32.28 Frames (supersedes P1364 26.6.20)

Change the proposal for Item 485 as follows:

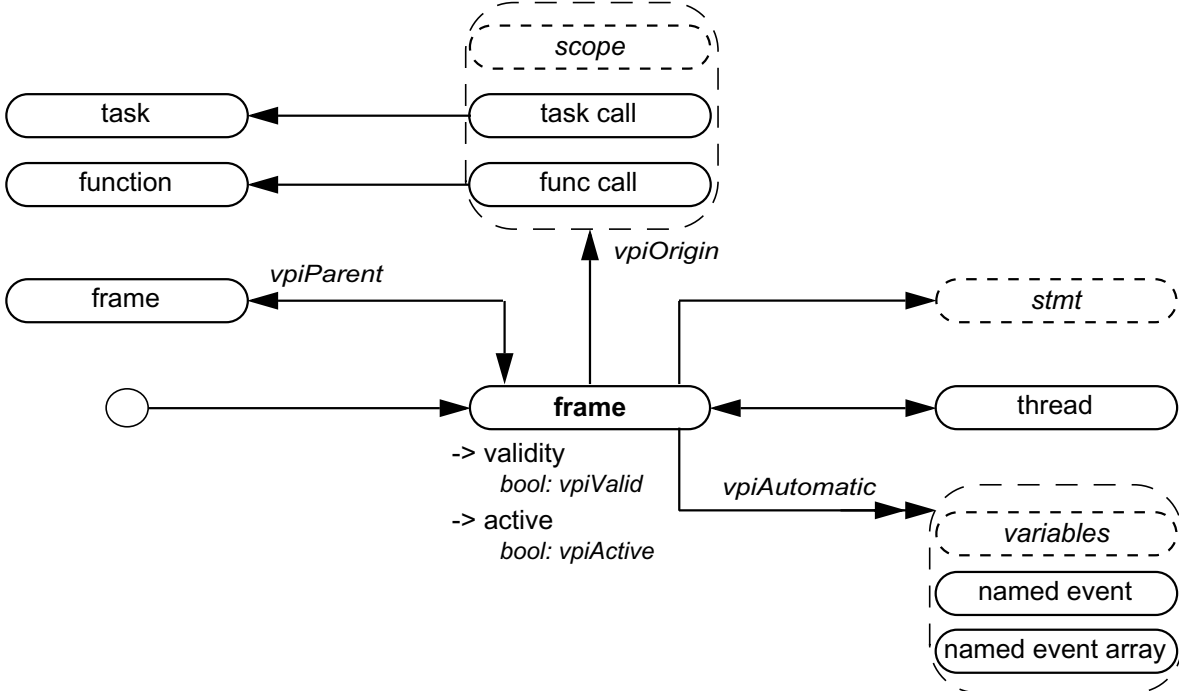
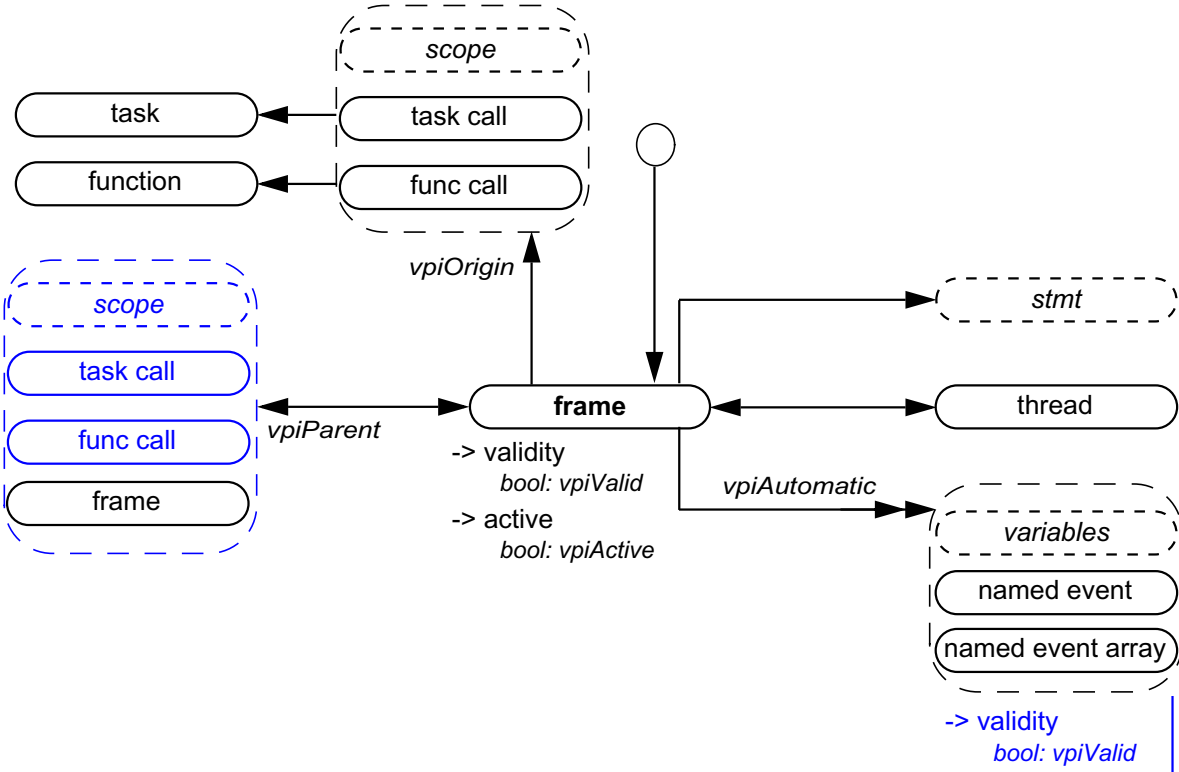
- | ~~7) The Frame object model is not backwards compatible with IEEE 1364-2005.~~
